**ZONING AMENDMENT
& SUBDIVISION STAFF REPORT****Date: October 21, 2004****NAME**South Florida Ceiling Systems (Joe Chambliss,
Agent)**LOCATION**Property on the North side of Bruns Drive, 50'±
West of its East terminus, and property 520'±
South of Grelot Road, adjacent to the North side of
Health Center Subdivision.**CITY COUNCIL
DISTRICT**

APPLICATION NUMBER 1 & 2 DATE October 21, 2004
APPLICANT South Florida Ceiling Systems (Joe Chambliss, Agent)
REQUEST Rezoning, Subdivision

SITE PLAN

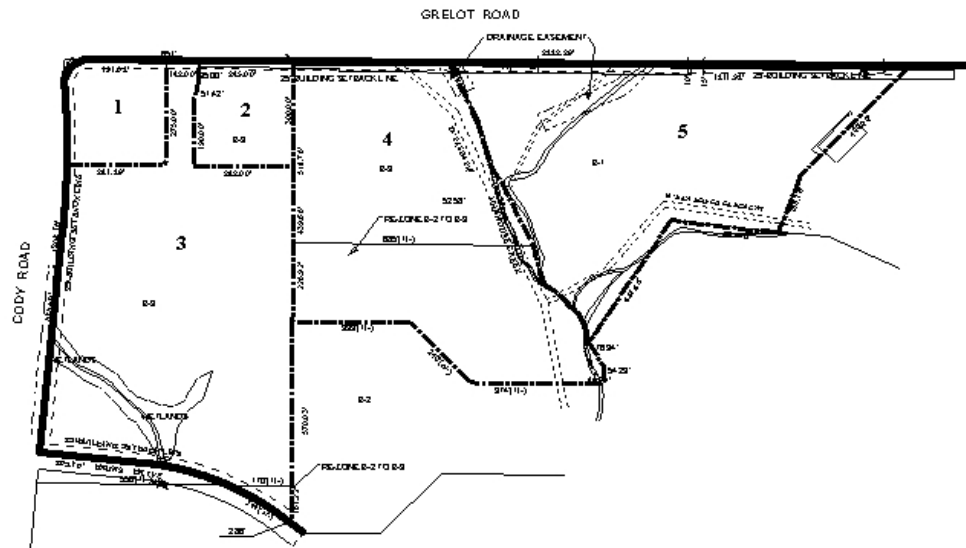
As required by the Subdivision Regulations, the Engineer/developer should provide contours and all drainage features of site. All areas receiving public water should be defined to properly evaluate site for development and drainage easement requirements. Must comply with all stormwater and flood control ordinances. Any work performed in the right of way will require a right of way permit.

While a site plan with a proposed use was not provided, the immediate plan for the property is to sell a lot(s); to create a legal lot of record, subdivision approval is required. However, the property is split-zoned, thus rezoning is also needed. As illustrated on the Vicinity Map, the majority of the site West of Milkhouse Creek is zoned B-3, Community Business. Moreover, the site is at the intersection of two major streets, a typical location for a community business district. While the southeast corner of Lot 4 will technically adjoin single-family residential development, Milkhouse Creek and the corresponding floodway would restrict development in the area adjoining residential property. It should also be noted that the proposed Lot 5 is split-zoned and that rezoning of Lot 5 was not submitted; therefore, Lot 5 should not be recorded until the lot is rezoned to one zoning classification.

Both Grelot and Cody Roads are planned major streets, and Grelot Road has an existing right-of-way in compliance with the Major Street Plan. The right-of-way for Cody Road is illustrated as variable; therefore, the dedication of any necessary right-of-way to provide 50-feet from the centerline of Cody Road should be required. Additionally, as the site fronts two major streets, access management is a concern; therefore, coordination with and approval by both Urban Development and Traffic Engineering should be required for the location, number and design of all curb cuts.

Rezoning Based upon the preceding, this application is recommended for approval subject to the following conditions: 1) dedication of any necessary right-of-way to provide 50-feet from the centerline of Cody Road, a planned major street; 2) coordination with and approval by both Urban Development and Traffic Engineering for the location, number and design of all curb cuts; 3) full compliance with the City Engineering

Subdivision Based upon the preceding, this application is recommended for Tentative Approval subject to the following conditions: 1) the elimination of split zoning prior to the recording of the final plat (lots may be recorded in phases); 2) dedication of any necessary right-of-way to provide 50-feet from the centerline of Cody Road, a planned major street; and 3) coordination with and approval by both Urban Development and Traffic Engineering for the location, number and design of all curb cuts.
